**REQUEST for AMENDMENT to
SITE DEVELOPMENT PLAN**

PROJECT 1002513

Sandia Foundation
Office Building
San Mateo Boulevard NE
Albuquerque, New Mexico

DRAWN BY: KK, MF, MB
REVIEWED BY: CRG
DATE: 05/05/03
PROJECT NO.: 03001
DRAWING NAME:
AMENDMENT to
SITE DEVELOPMENT
PLAN

SHEET NO.
C-1(A)
OF

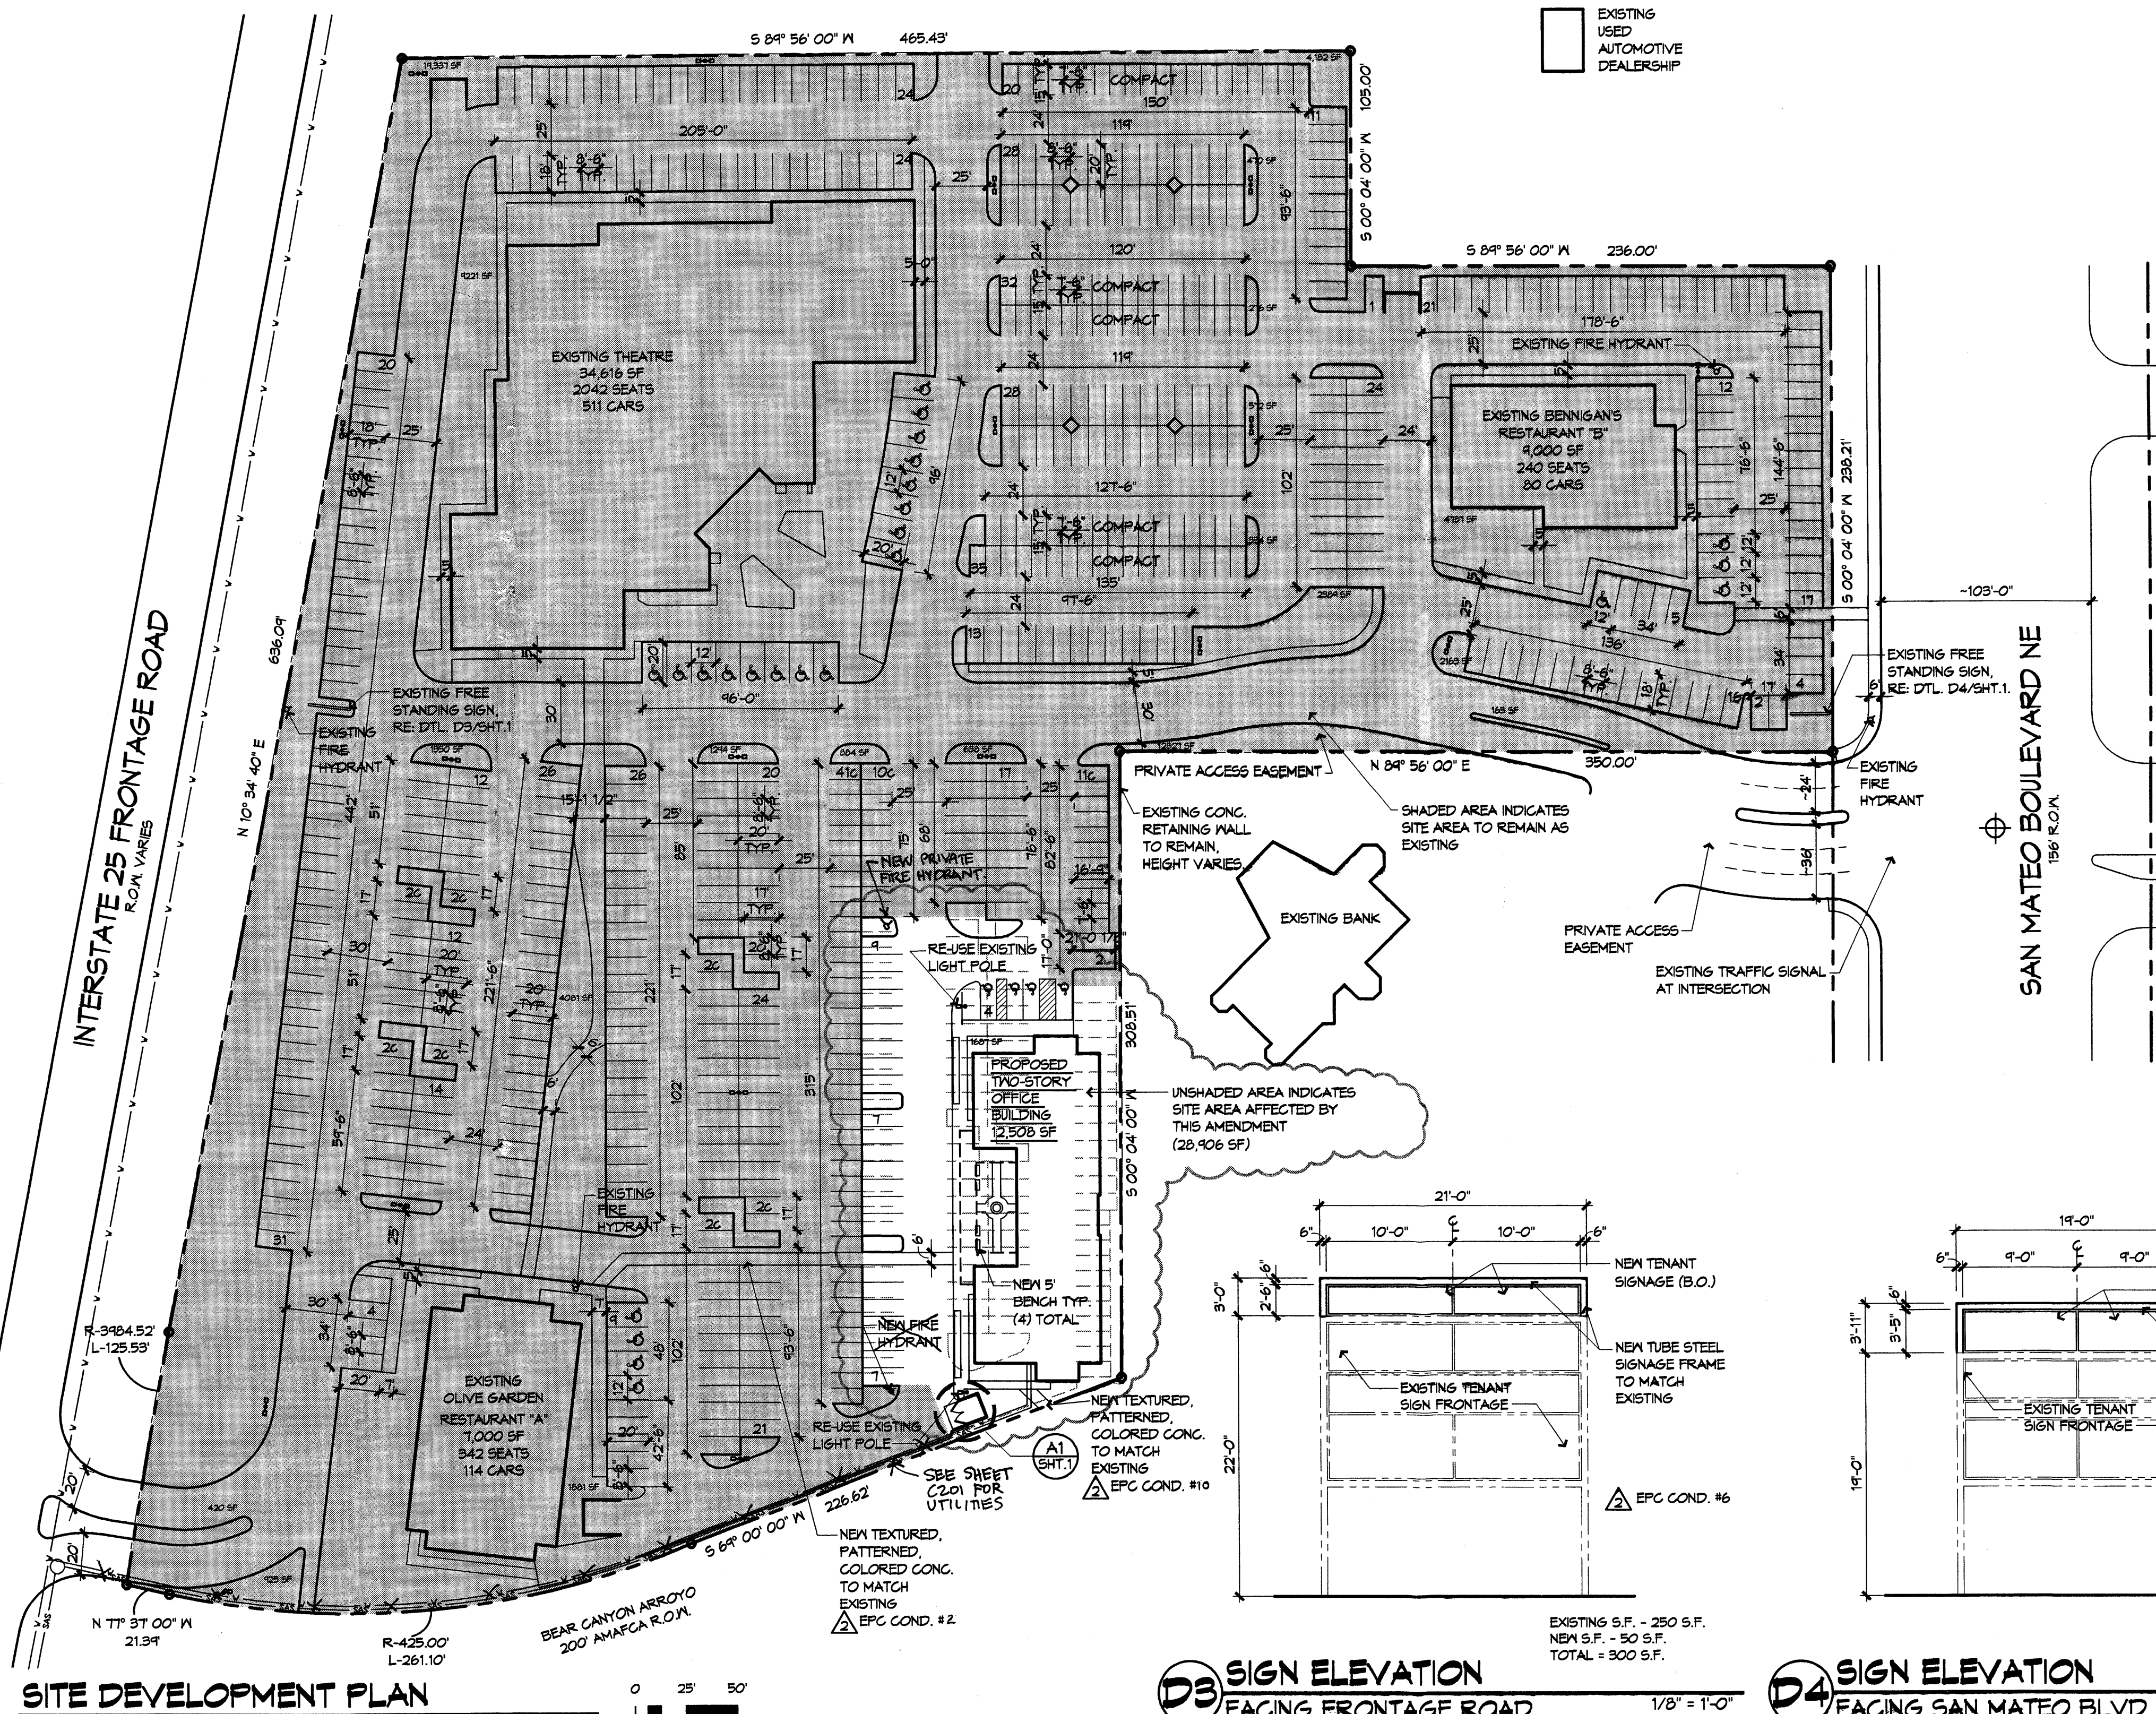
- △ REQUESTED REVISIONS TO SITE PLAN:
- △ REVISION TO PARKING AREA
- △ REVISION TO BUILDING AREA

SITE DEVELOPMENT PLAN
SCALE: 1"=50'

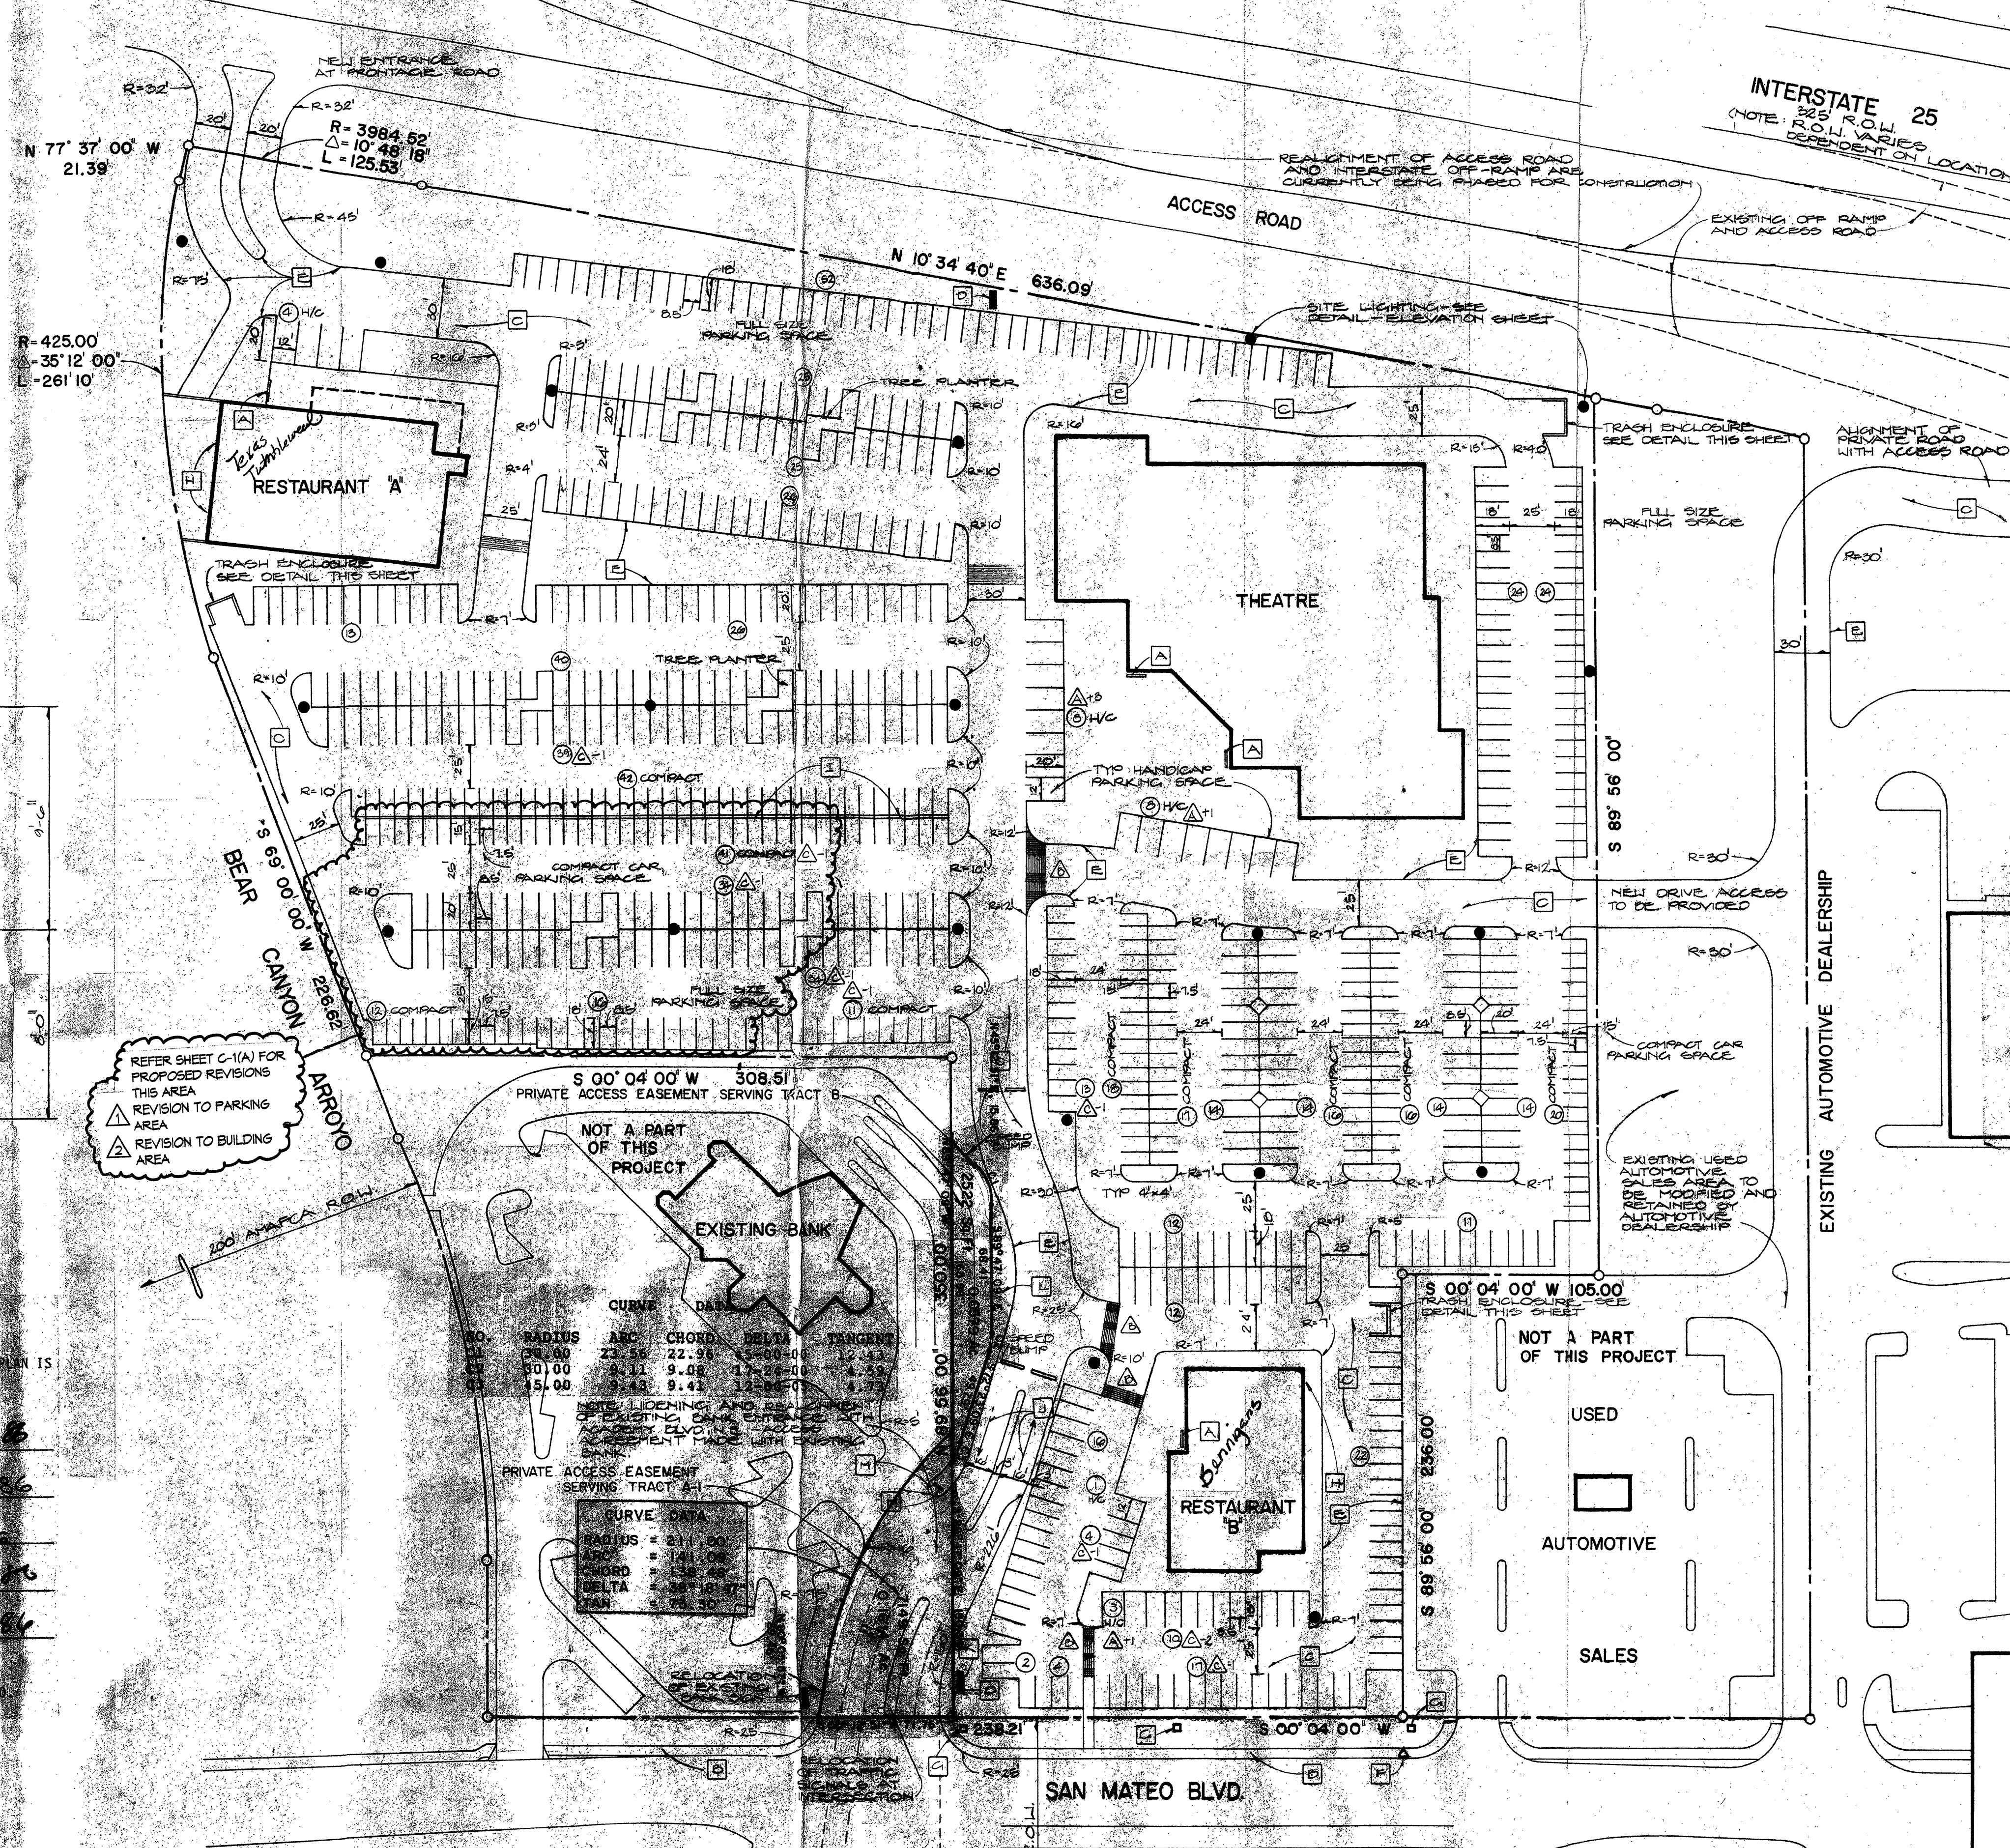
- KEYED NOTES**
- Bicycle Rack Location
 - Existing Sidewalk/Gutter
 - Asphalt Paving
 - Major Freestanding Sign Location: 250 S.F. Face and 26' Height Allowance as to Current City Standards
 - 6" Concrete Curb - Typical
 - Existing Fire Hydrant
 - Existing Light Standards
 - Service Area - All Deliveries to be Made During Non-Operational Restaurant Hours
 - Install continuous 8" standing curb, break curb only for drainage requirements.
 - Paint directional arrows.
 - Movie marquees to be positioned out of Bank Sign sight line.
 - Install evergreen plant screen adjacent to driveup.
 - Rework radius into Bank Drive-up.
 - Install flashing yield sign at North entry to bank.
- CHANGES TO SITE PLAN
DUE TO E.P.C. COMMENTS
OF FEBRUARY 20, 1986

- △ Handicap parking spaces added at each building location. Additional amount designated in specific area.
- △ Improved pedestrian access between San Mateo Blvd. and restaurant B. Also, between restaurant B and the Theatre, textured walks were added (see also landscape plan for sidewalk location).
- △ Parking space reductions or additions due to the above changes and change amount designated in specific area.

REFER SHEET C-2(A) FOR PROPOSED REVISIONS THIS AREA
